ZONING CHANGE REVIEW SHEET

CASE: C14-2016-0020 – Lantana IV**P.C. DATE:** August 9, 2016

ADDRESS: 7717 Southwest Parkway**DISTRICT AREA:** 8**OWNER/APPLICANT:** JDI Holdings, LLC (Douglas Ivey)**AGENT:** Sprouse Shrader Smith (Terry Irion)**ZONING REQUEST FROM:** LR-NP**TO:** GR-MU-NP**AREA:** 9.59 acres**SUMMARY STAFF RECOMMENDATION:**

Figure 1

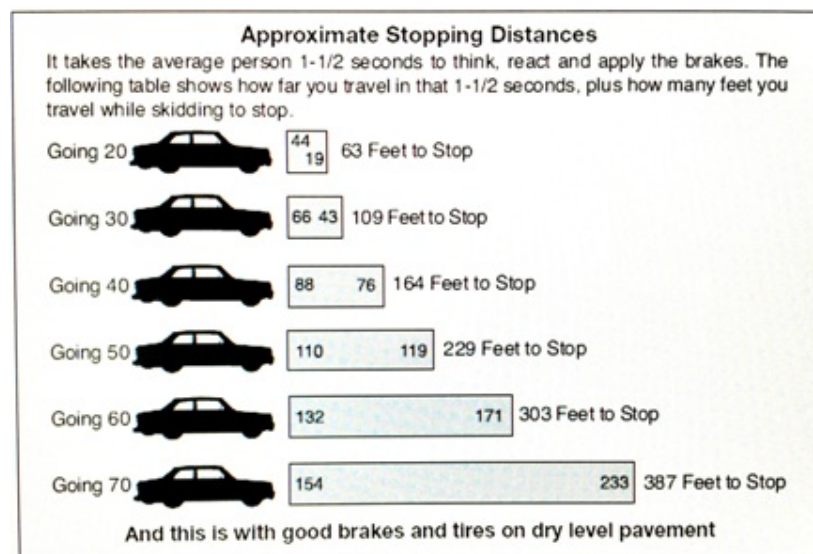
While all this data is important, the closing speed data, Table 5 and Figure 1, should be considered most carefully. Since there exists no lane for acceleration for vehicles making right or left turns onto Southwest Parkway where traffic is flowing at anywhere from 55 to 80 MPH, the turning vehicle has only seconds to get up to the traffic flow speed. In fact, if the flow is moving at 70 MPH an oncoming vehicle will cover the very short 528-foot sight distance in 7.5 seconds. Conservatively assuming it takes a turning driver 4 seconds to evaluate the situation in this uncontrolled median (i.e. look to the right to see oncoming traffic, look in front to see that no vehicle is going to go cross your path as you turn left, look toward your left to see if any vehicles in the oncoming left turn lane are initiating their turning movement, and then move one's foot from the brake to the gas), in the ensuing 7.5 seconds that it takes a vehicle to traverse the 528-foot sight distance range, the turning vehicle has but 3.5 seconds to accelerate to match the traffic flow and keep from either getting hit or becoming a roadway hazard. Virtually, no typical roadway vehicle accelerates from 0 to 70 MPH in 3.5 seconds. Table 5 shows the oncoming vehicle will have traveled 412 feet, leaving only 116 feet to identify the potential hazard and stop in case of an emergency, for example if the turning vehicle were to stall unexpectedly. The Texas Department of Public Safety prepared Figure 1 states that at 70 MPH the oncoming vehicle would need a minimum of 387 feet to stop. If the oncoming vehicle is distracted or boxed in its traffic lane to prevent taking avoidance action, a potentially deadly accident would be inevitable. This is the reality of the Southwest Parkway at Terravista intersection right now. This is certainly not the situation for the William Cannon at Rialto intersection.
